US.1 PEDESTRIAN OVERPASS STUDY

January 26th, 2000
July 7th, 2000 - Revised

MCHARRY ASSOCIATES

RE: City of South Miami, Pedestrian Overpass
At South Dixie Highway (US-1) near Sunset Drive

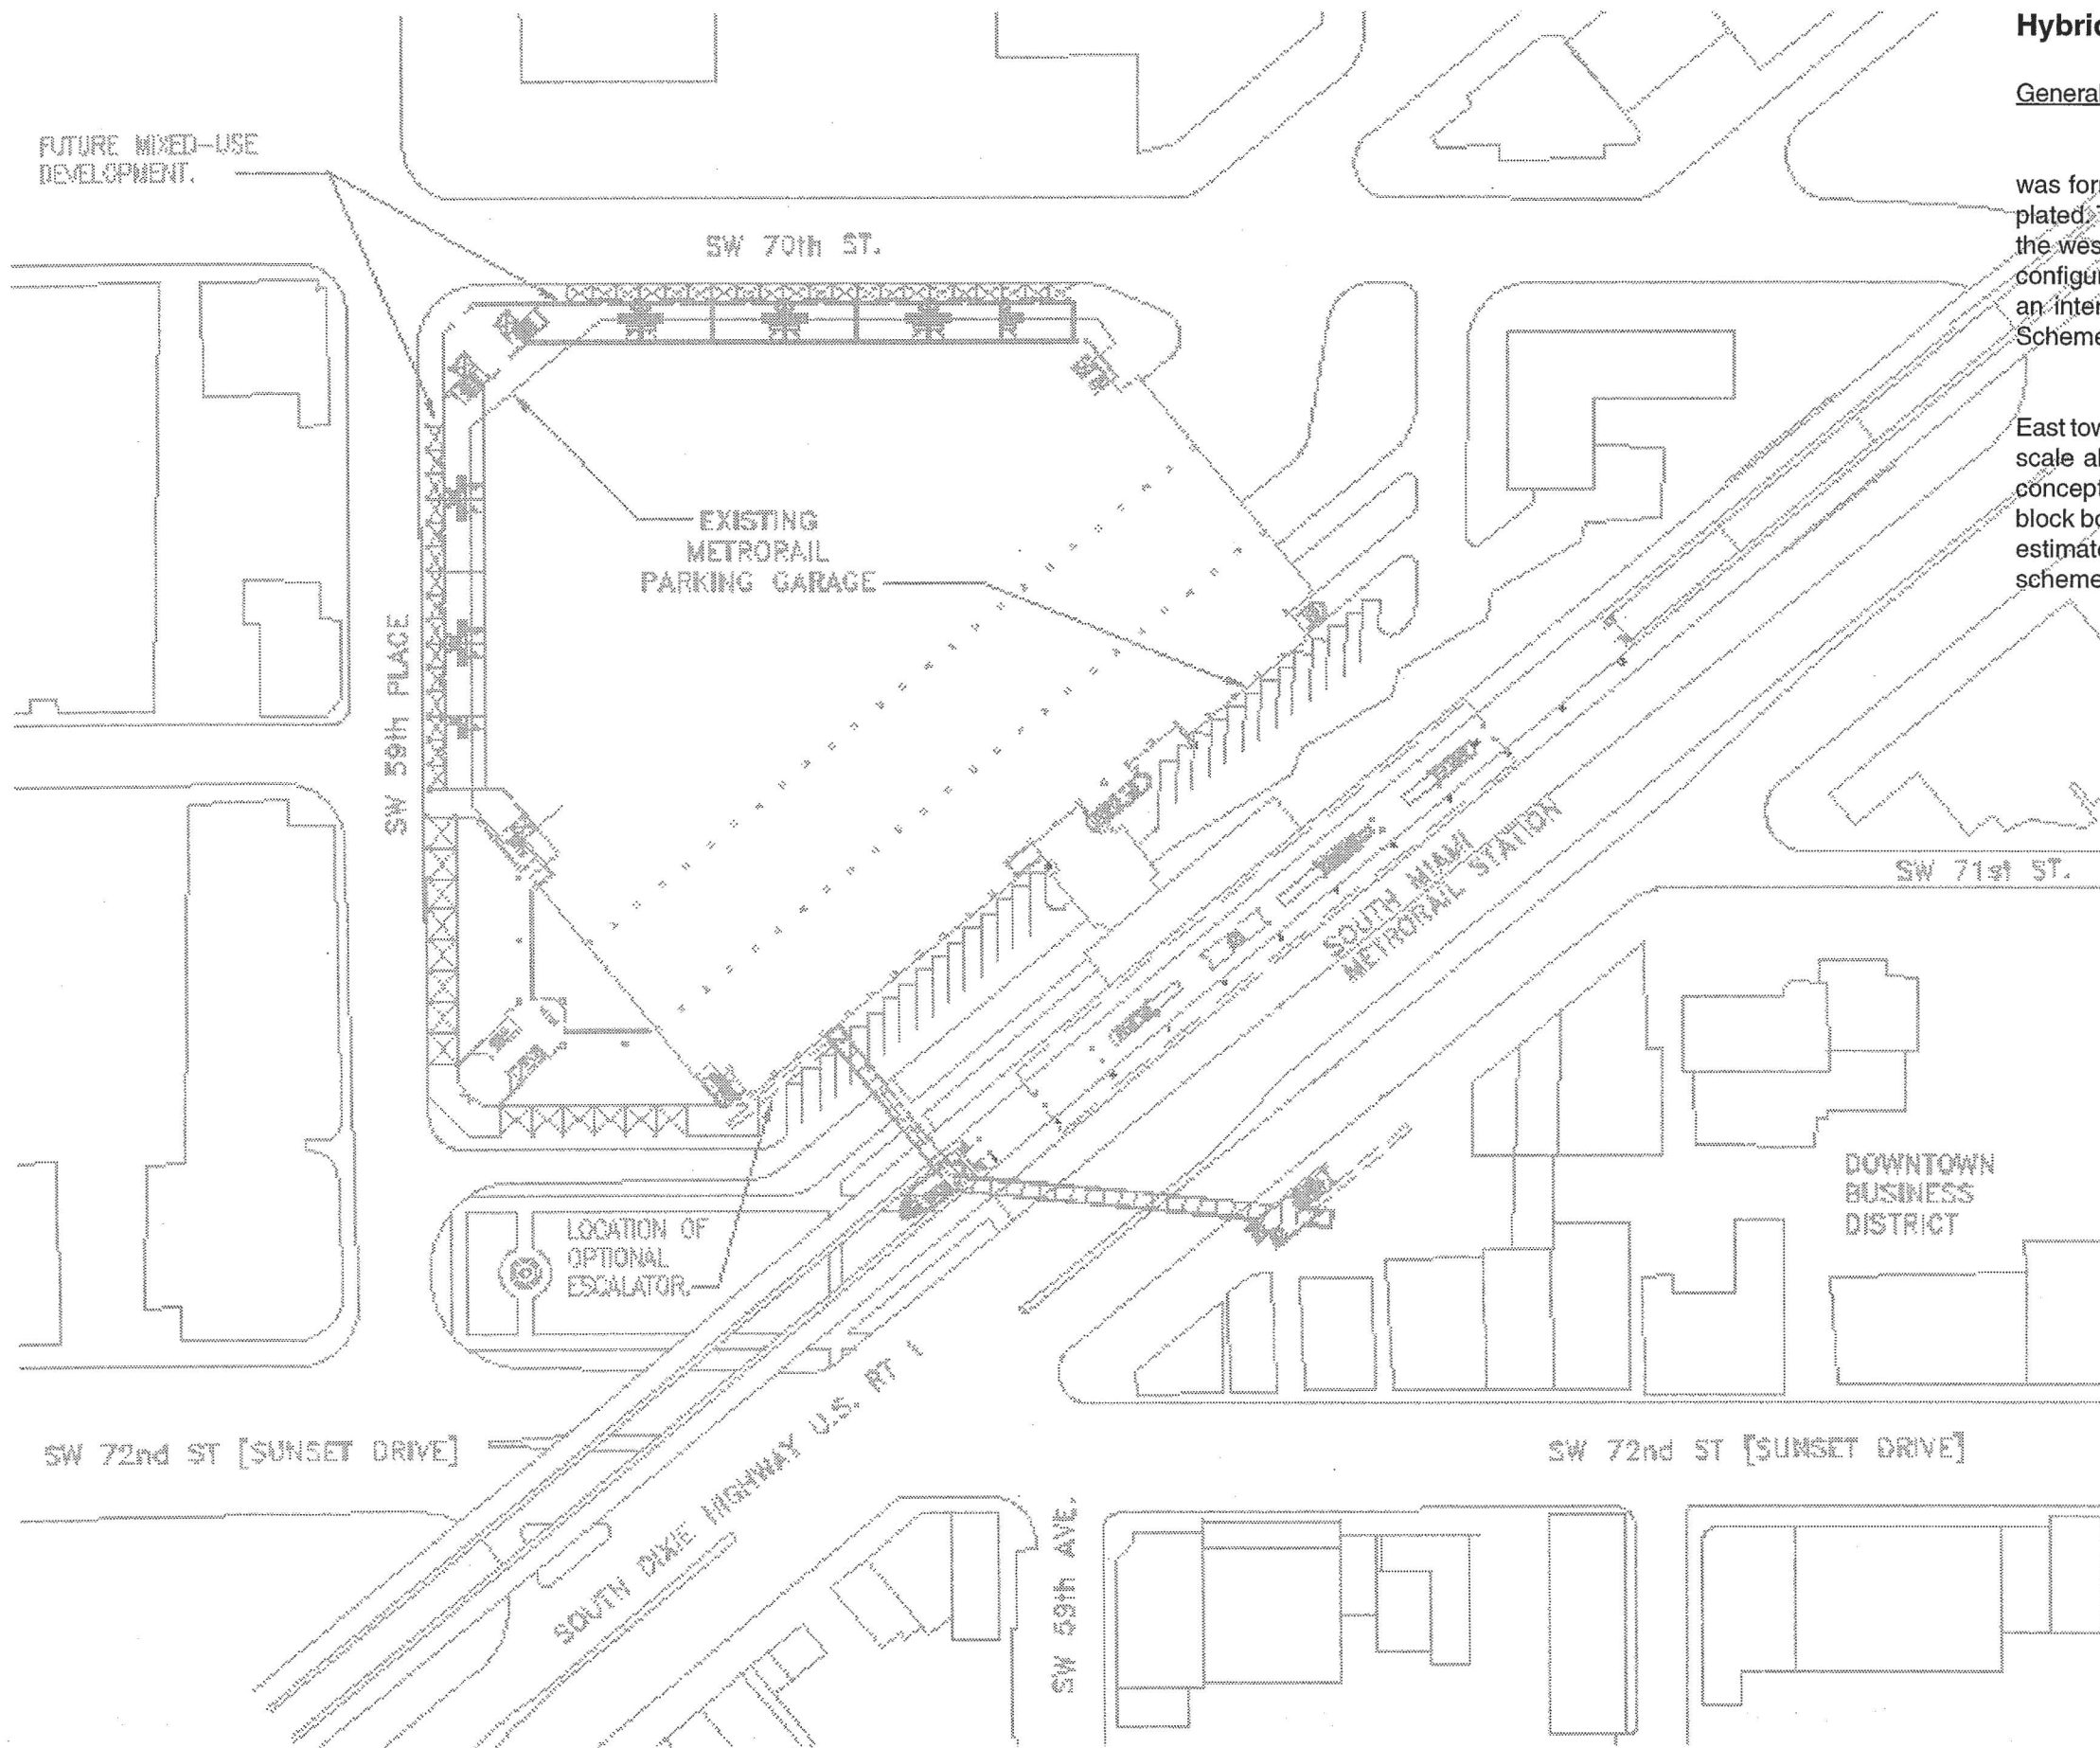
Force Peds to enter the garage
Drop off to nowhere
Overhang?
